**ADDENDUM NO. 4**  
**Penguin Life Support System Upgrade**  
**REQUEST FOR BIDS #11-1717**  
**September 3, 2010**

THE FOLLOWING ARE CHANGES TO THE CONTRACT DOCUMENTS

SHEET NO.: RC 03  
 REFERENCE SHEET NO.: C4.0

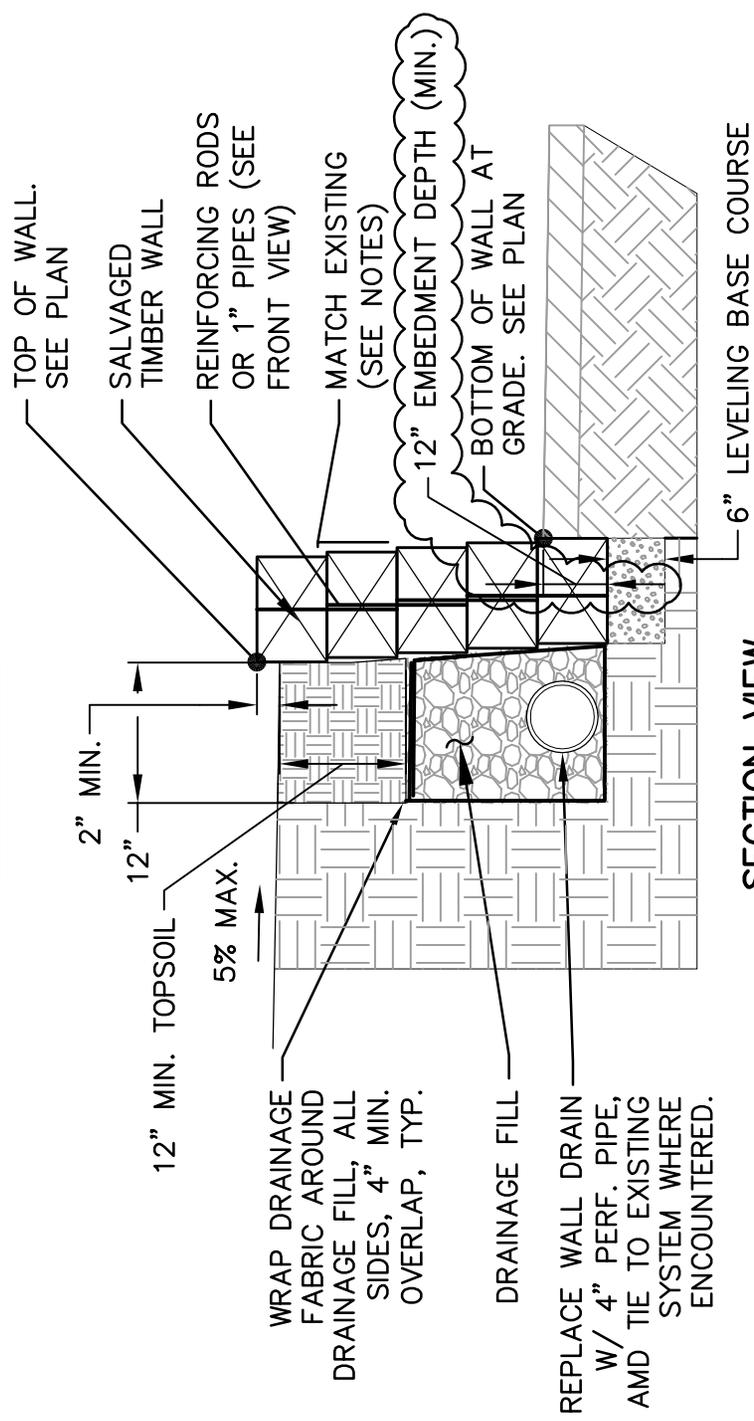
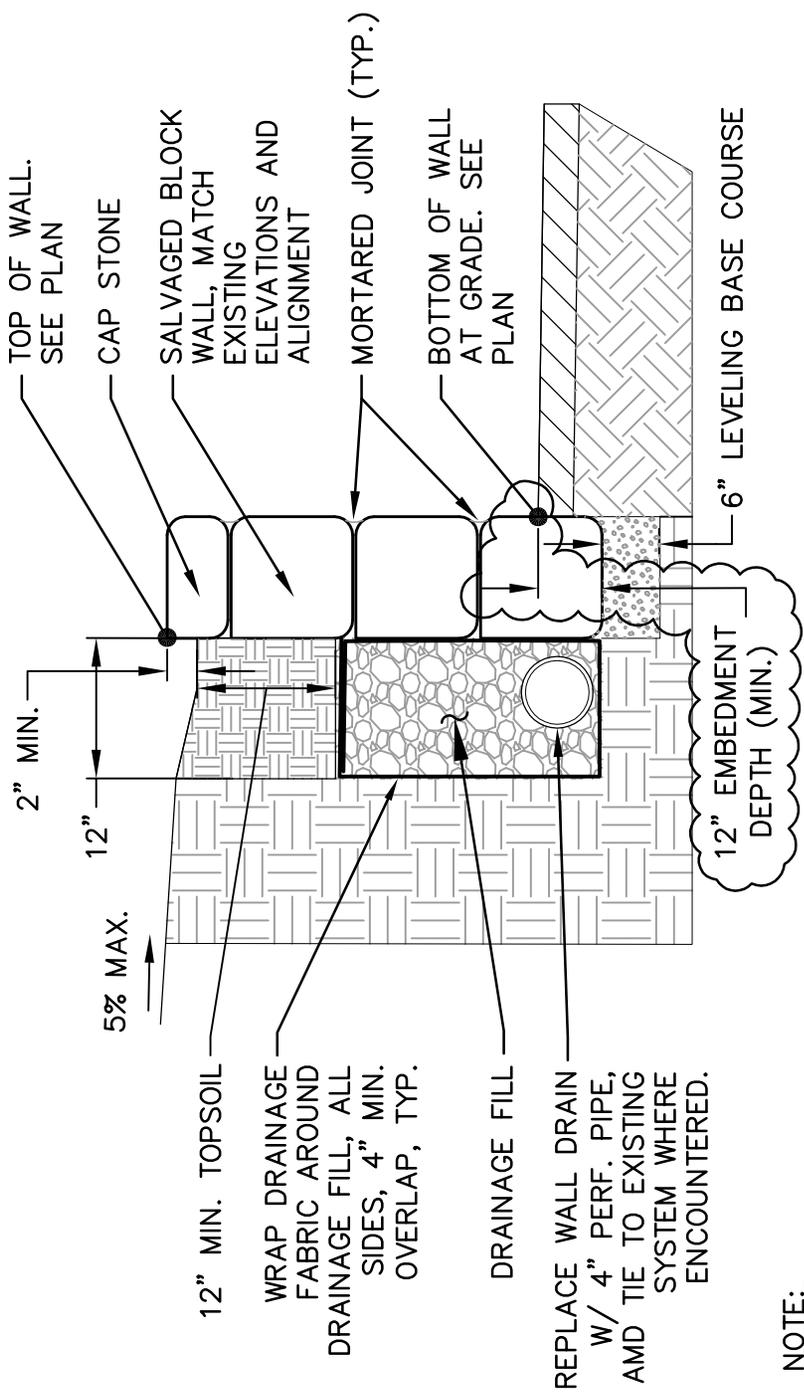
A. DRAWING RC03 NAME: C4.0 CIVIL DETAILS, DETAIL 5, REVISION MADE:

1. As shown on drawing.

1. CONTRACTOR TO INSPECT EXISTING CONDITION OF THE TIMBER WALL AND VERIFY WITH ARCHITECT THAT THE TIMBERS ARE SUITABLE FOR REUSE.
2. CONTRACTOR TO INSPECT THE EXISTING WALL CONSTRUCTION AND MATCH THE EXISTING BATTER.

SHEET NO.: RC 04  
REFERENCE SHEET NO.: C4.0

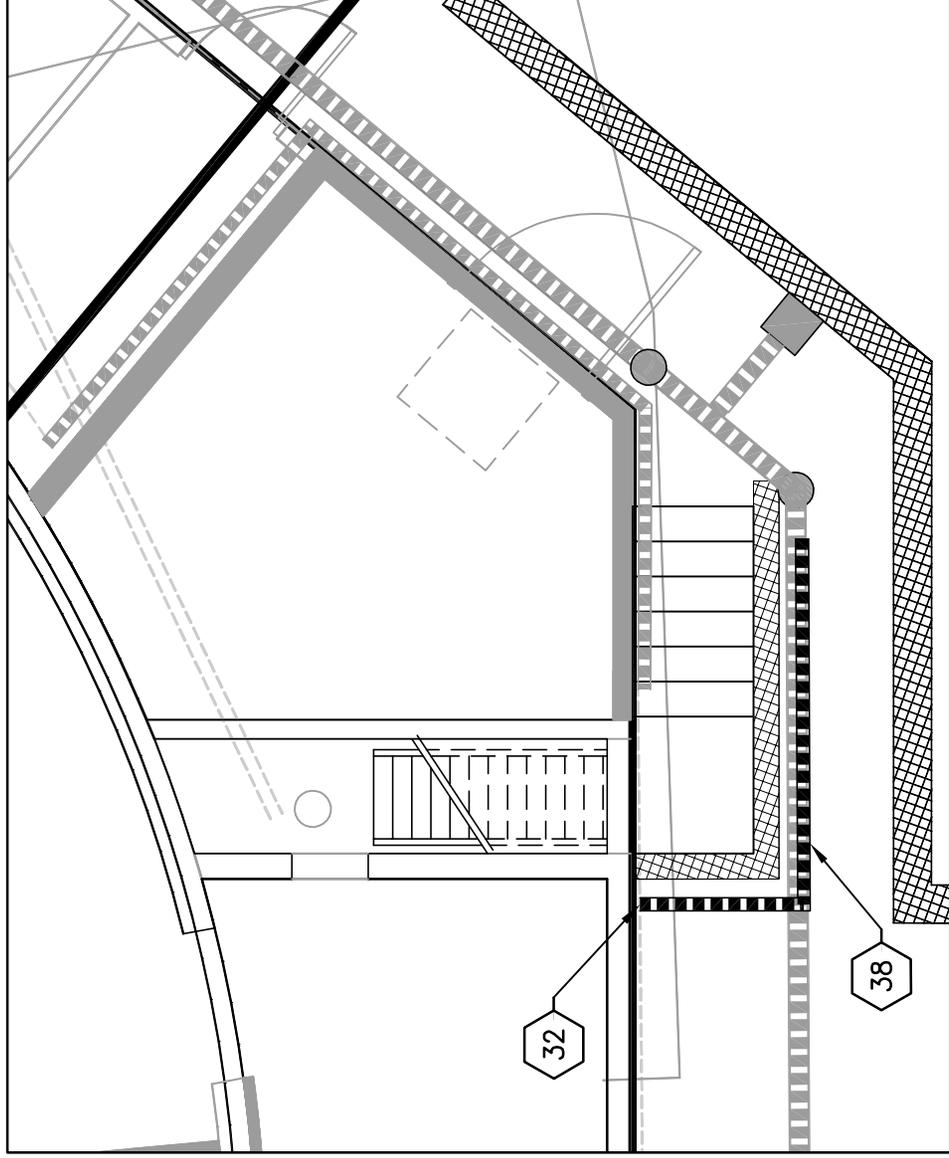
B. DRAWING RC04 NAME: C4.0 CIVIL DETAILS, DETAIL 4, REVISION MADE:

1. As shown on drawing.

1. CONTRACTOR TO VERIFY AND MATCH EXISTING WALL CONSTRUCTION.

RC 05

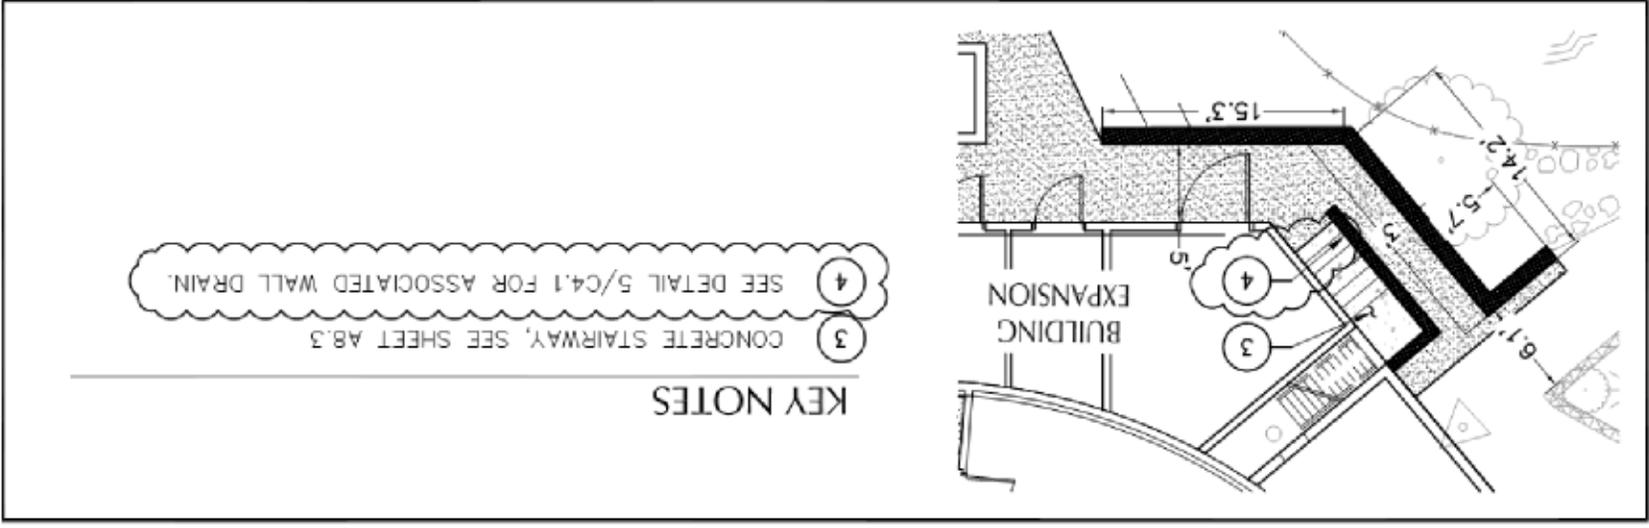
C. DRAWING RC05 NAME: C4.1 CIVIL DETAILS, DETAIL 5, ADD:

1. ADD detail 5 as shown on drawing.

- 32 INTERCEPT EXISTING FOUNDATION DRAIN
- 38 INSTALL 14 LF OF 4" PVC FOUNDATION DRAIN PER WALL ASSEMBLY

SHEET NO.:  
RS01  
REFERENCE SHEET NO.:  
1/S2.1

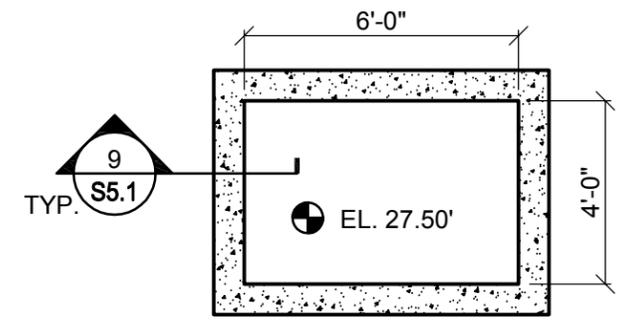
D. DRAWING RS01 NAME: S2.1 FRAMING PLANS, DETAIL 1, REVISION MADE:

1. As shown on drawing.

SHEET NO.:  
RS02  
REFERENCE SHEET NO.:  
S2.1

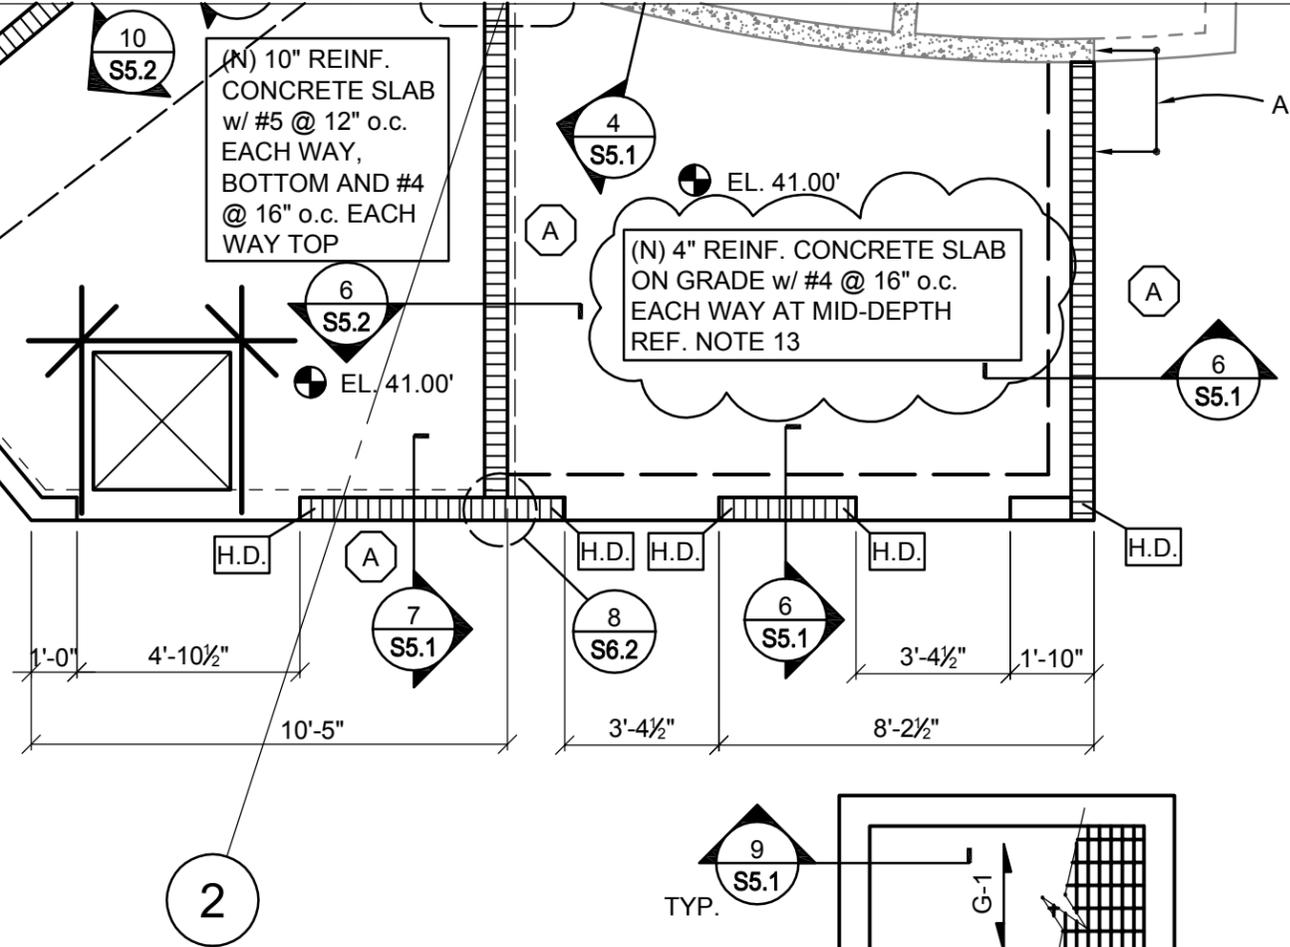
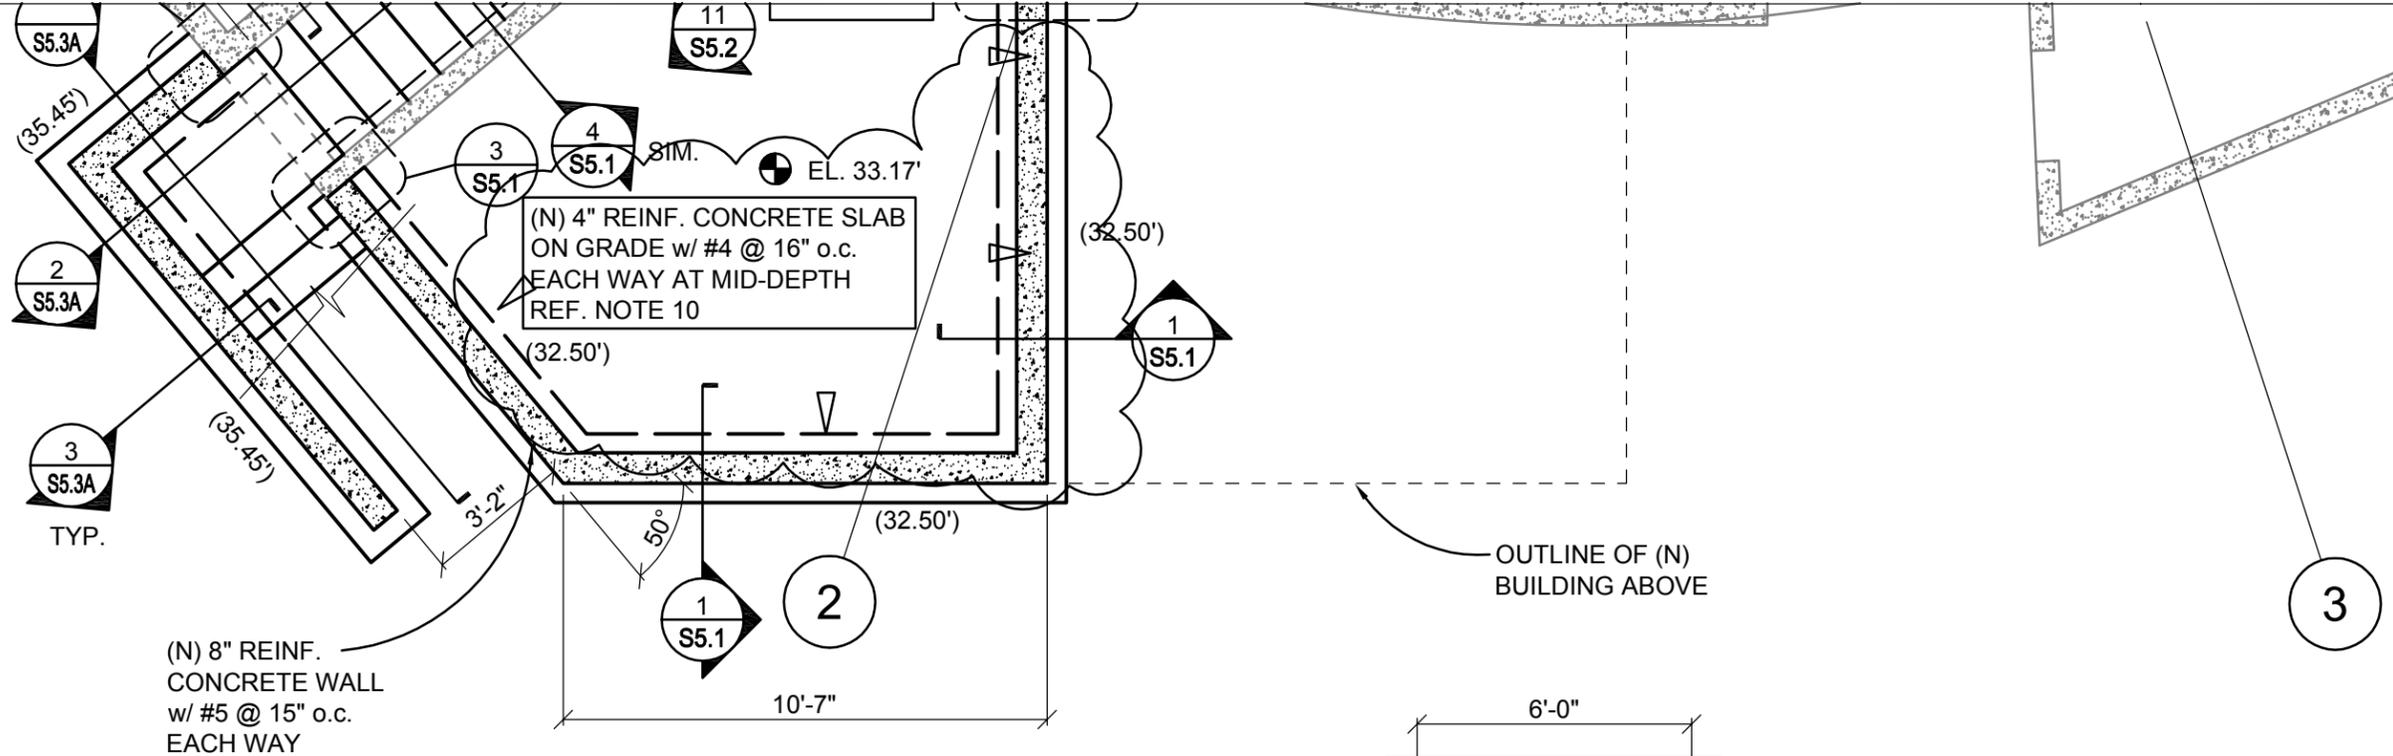
E. DRAWING RS02 NAME: S2.1 FRAMING PLANS, DETAIL 2, REVISION MADE:

1. As shown on drawing.

RS05

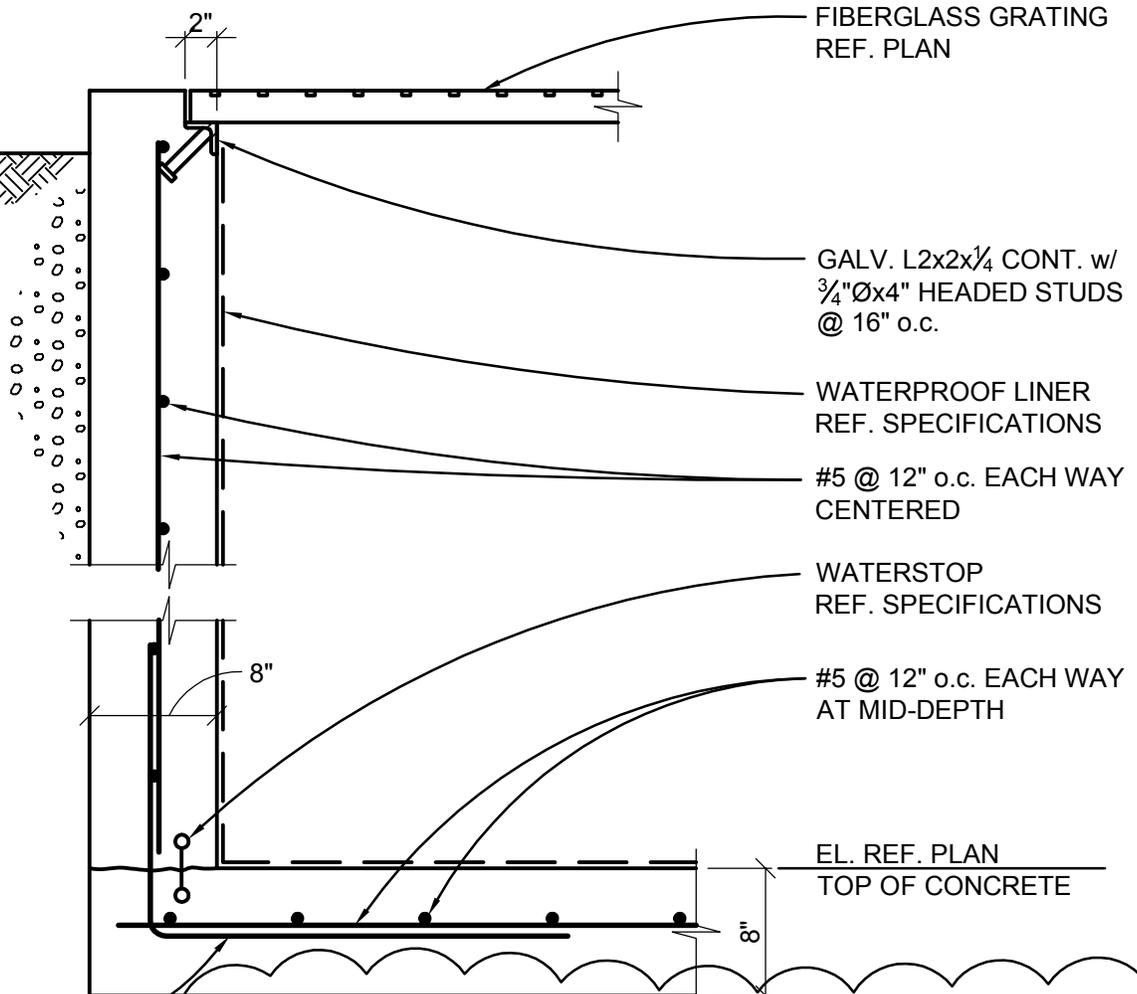
H. DRAWING RS05 NAME: S5.1 CONCRETE DETAILS, DETAIL 1, REVISION MADE:

1. As shown on drawing.

SHEET NO.:  
RS06

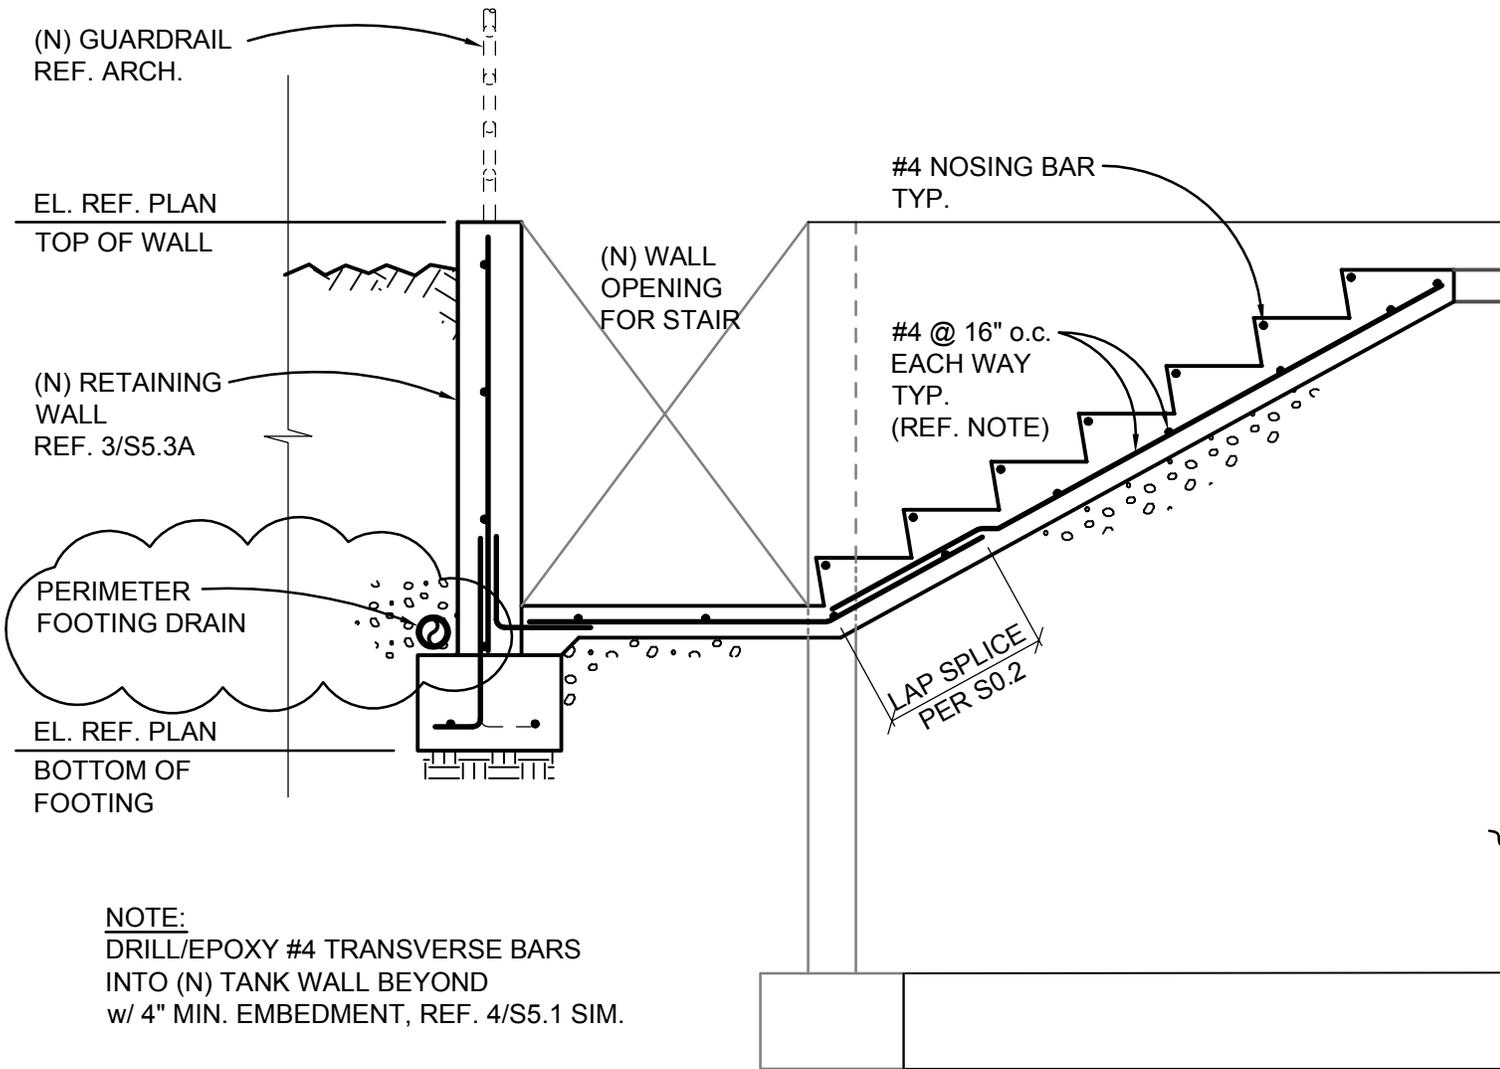
I. DRAWING RS06 NAME: S5.1 CONCRETE DETAILS, DETAIL 9, REVISION MADE:

1. As shown on drawing.
